APPLICATION No. **16/03049/MNR**

LOCATION: 40 LADY MARY ROAD, PENYLAN, CARDIFF, CF23 5NT
PROPOSAL: PROPOSED DEMOLITION OF EXISTING DWELLING AND CONSTRUCTION OF A 4 STOREY RESIDENTIAL DEVELOPMENT COMPRISING FOUR 2 BED APARTMENTS AND A TWO STOREY 2 BED MAISONETTE WITH ON SITE PARKING, AMENITY, CYCLE AND REFUSE STORAGE FACILITIES

Roof Plan

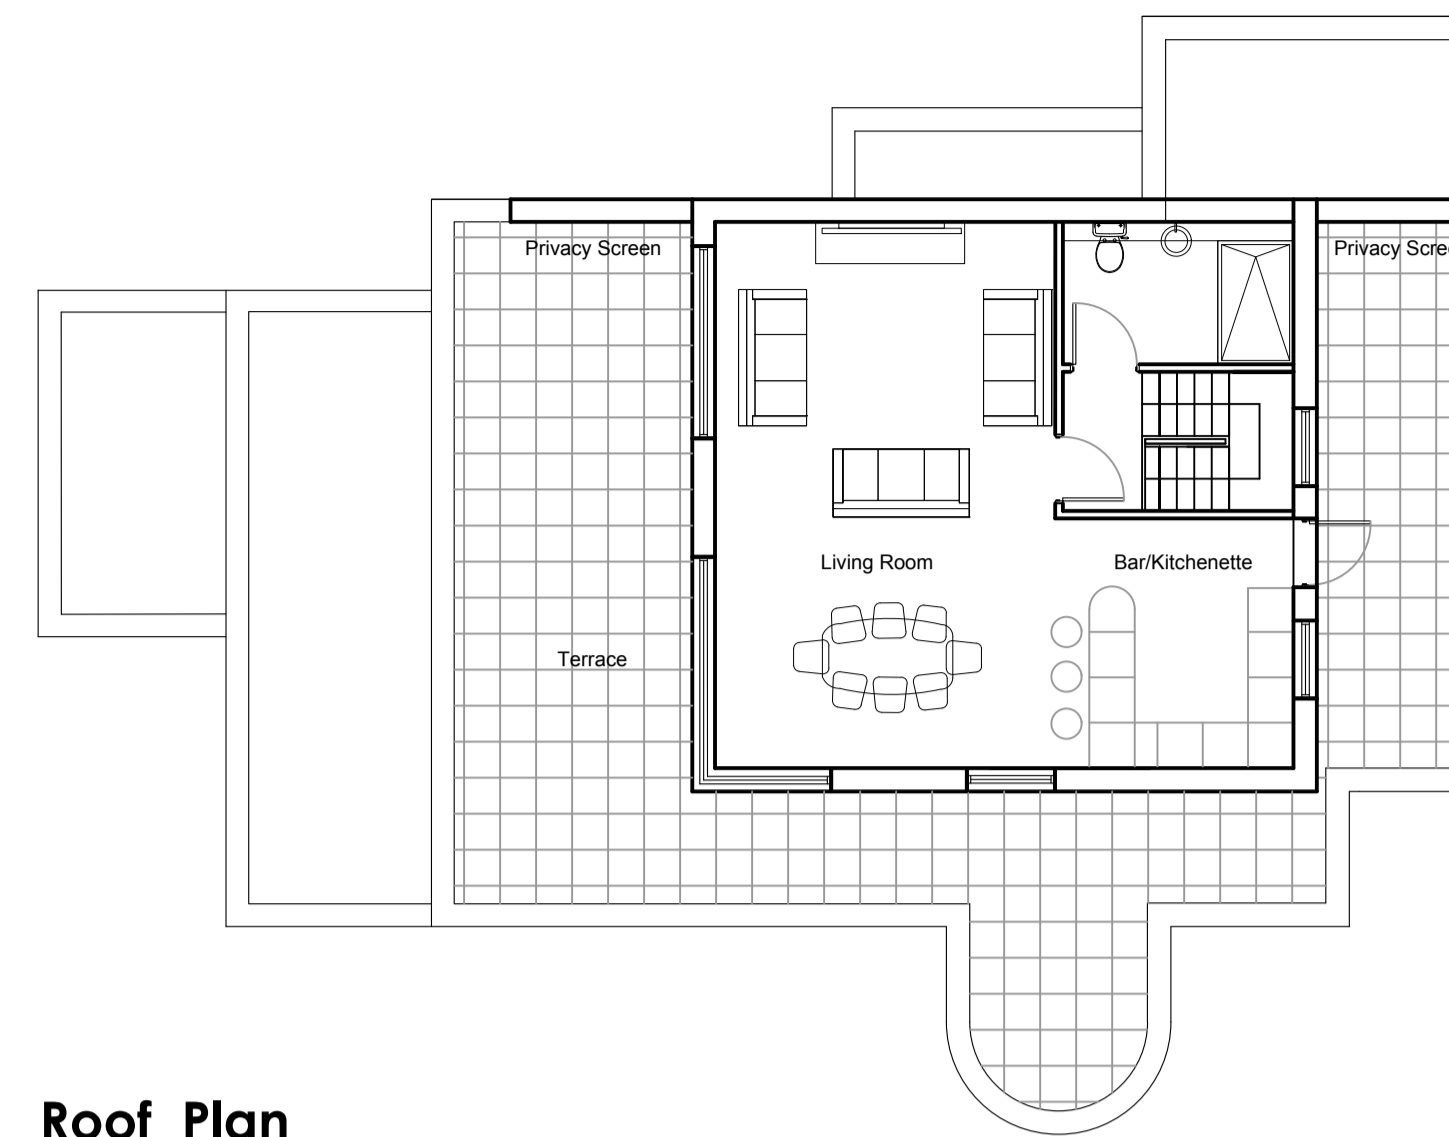
6. The privacy screens, shown on the Roof Plan dwg. no. AL(01)01, shall be provided to a minimum height of 1.7m from the floor level of the terrace in materials to match the building.
Reason: To protect the privacy of neighbouring occupiers in accordance with Policies KP5 of the Cardiff Local Development Plan 2006-2026.

Proposed Residential Building 40 Lady Mary Road, Lakeside Mr & Mrs Ciocca		Job No. 10_66	Rev. A
Proposed Plans		Dwg No. AL(01)01	
Date 15/12/16	Drawn MC	Scale 1:100/500 @ A1 - 1:200/1000 @ A3

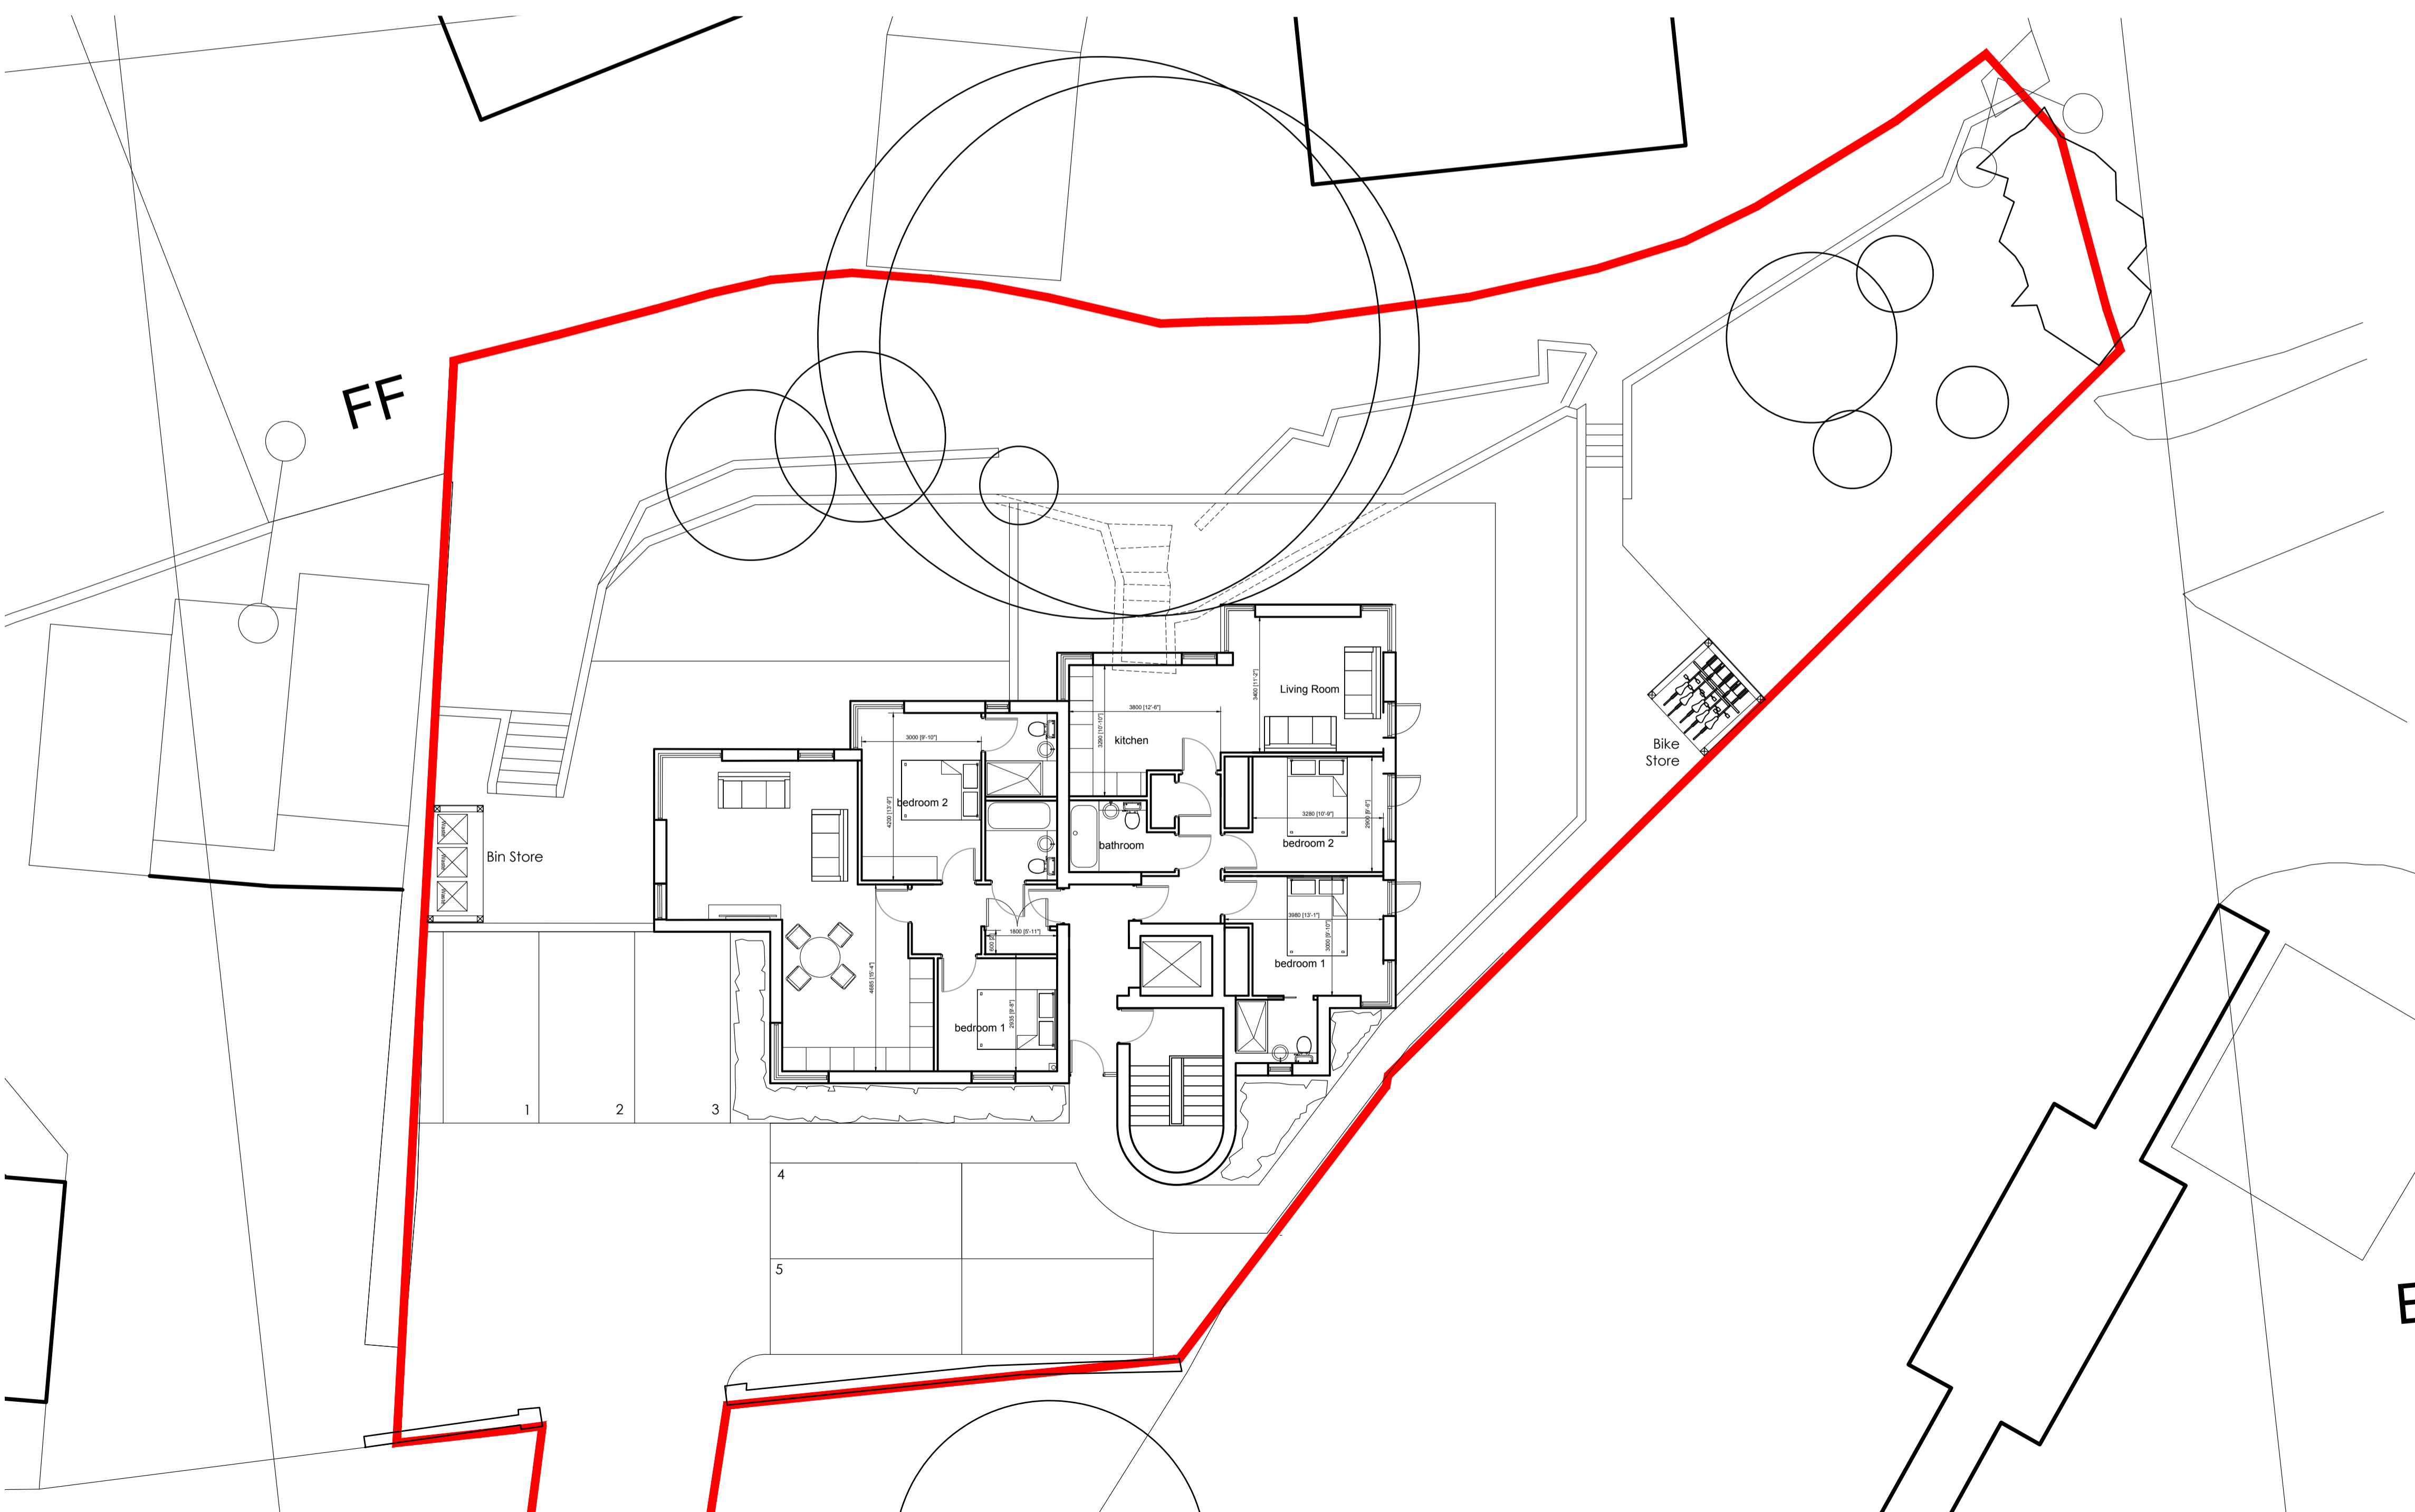
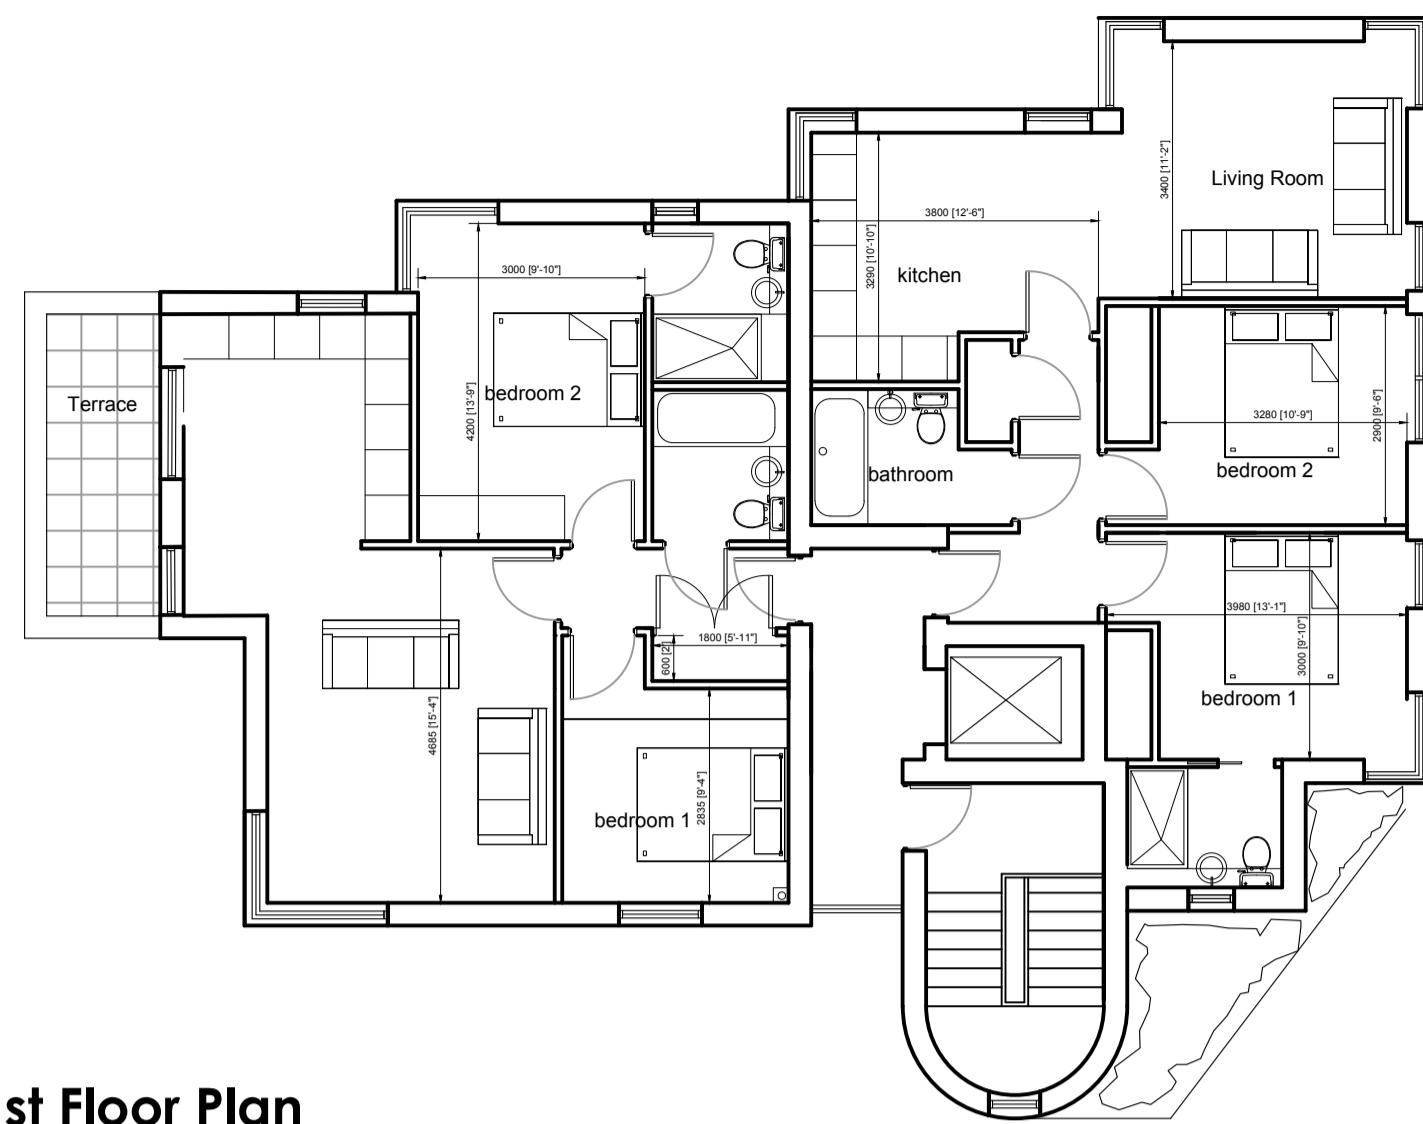
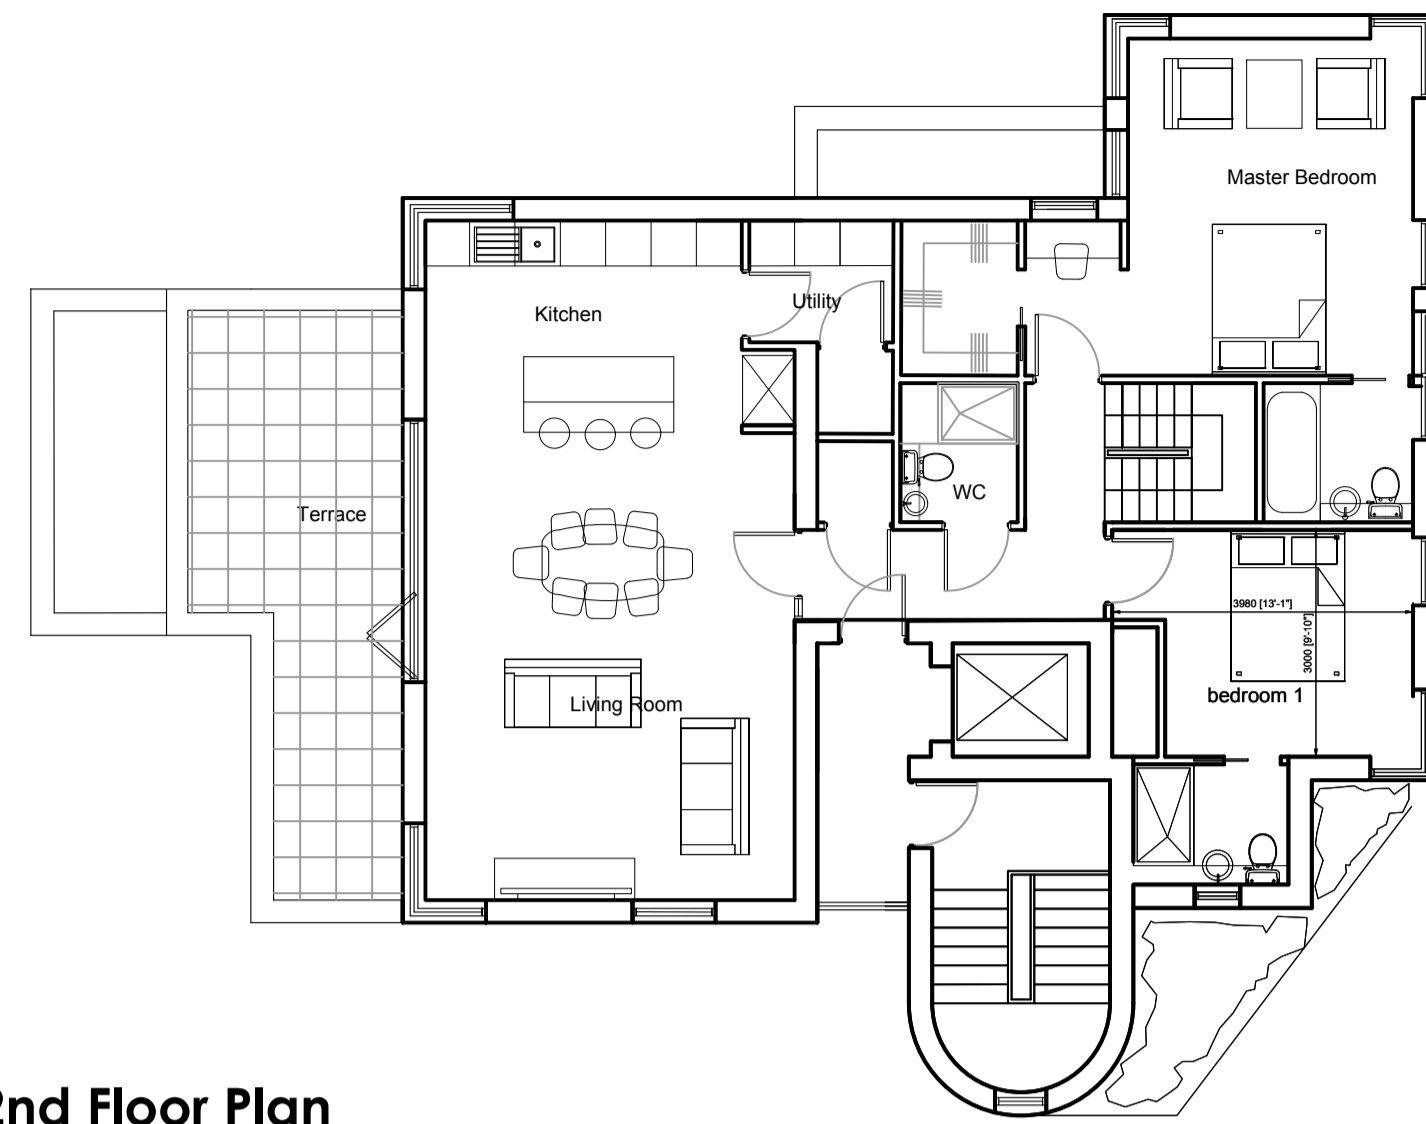
7. Notwithstanding the submitted details (dwg. no. AL(01)01, AL(01)01/A and AL(90)03/B) prior to beneficial use of the development hereby submitted a secure and undercover bicycle store, providing for 10 spaces, shall be provided in accordance with details which have been approved by the Local Planning Authority.
Reason: To promote sustainable modes of transport in accordance with Policies KP8 and T5 of the Cardiff Local Development Plan 2006-2026.

10. Notwithstanding the submitted details (dwg. no. AL(01)01, AL(01)01/A and AL(90)03/B) prior to beneficial occupation of the development hereby permitted a refuse storage facility shall be provided in accordance with further details which shall have been approved by the Local Planning Authority.
Reason: In the interests of visual amenity and to secure an orderly form of development in accordance with Policies KP5 and W2 of the Cardiff Local Development Plan 2006-2026.

Proposed Residential Building	Job No. 10_66
40 Lady Mary Road, Lakeside	Drawn No. AL(01)02
Mr & Mrs Ciocca	Rev. 1
Title: Proposed Elevations	
Date: 15/12/16	Drawn: MC
Scale: 1:100 @ A1 - 1:200 @ A3

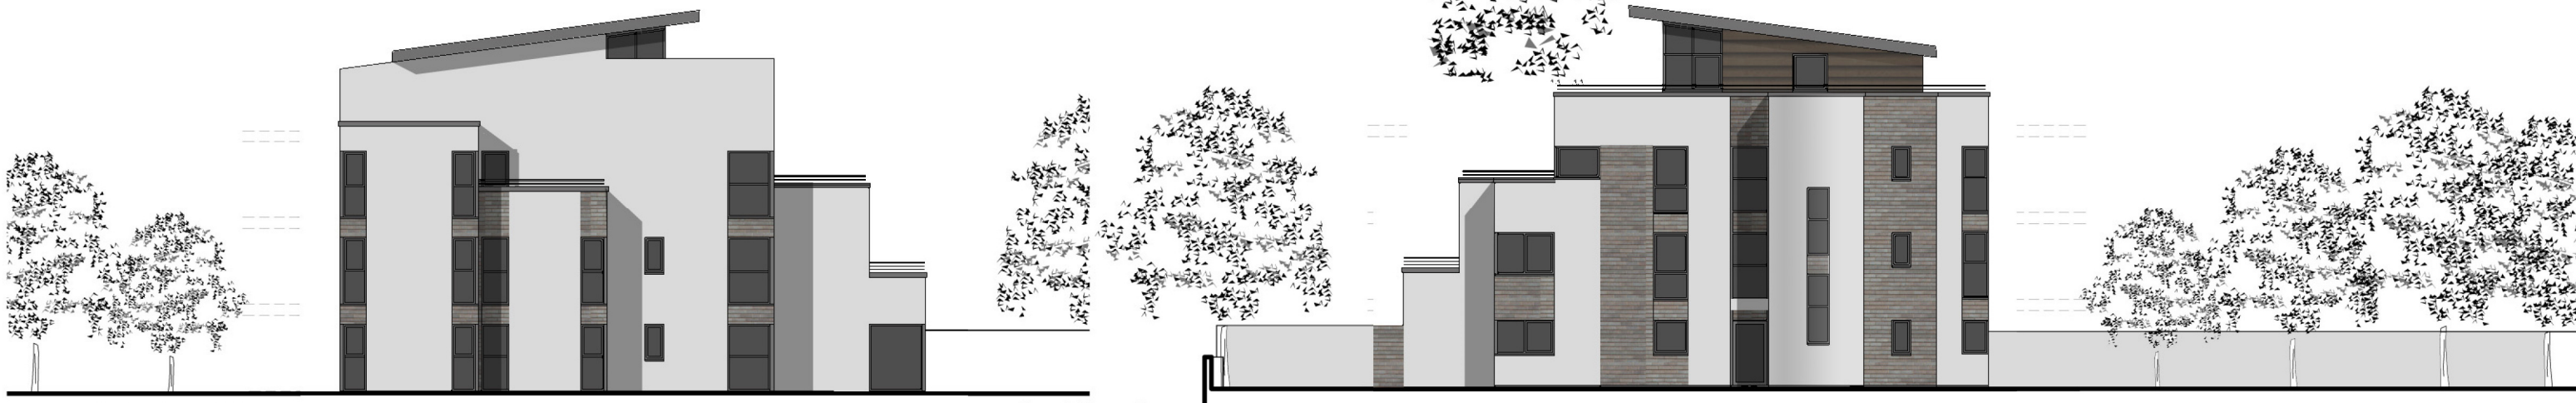
5. Prior to beneficial occupation the north facing windows within the rear elevation, on the first and second floors, shall be obscurely glazed and non-opening below a height of 1.7m from internal floor level and thereafter so retained.
Reason: To protect the privacy of neighbouring occupiers in accordance with Policies KP5 of the Cardiff Local Development Plan 2006-2026.
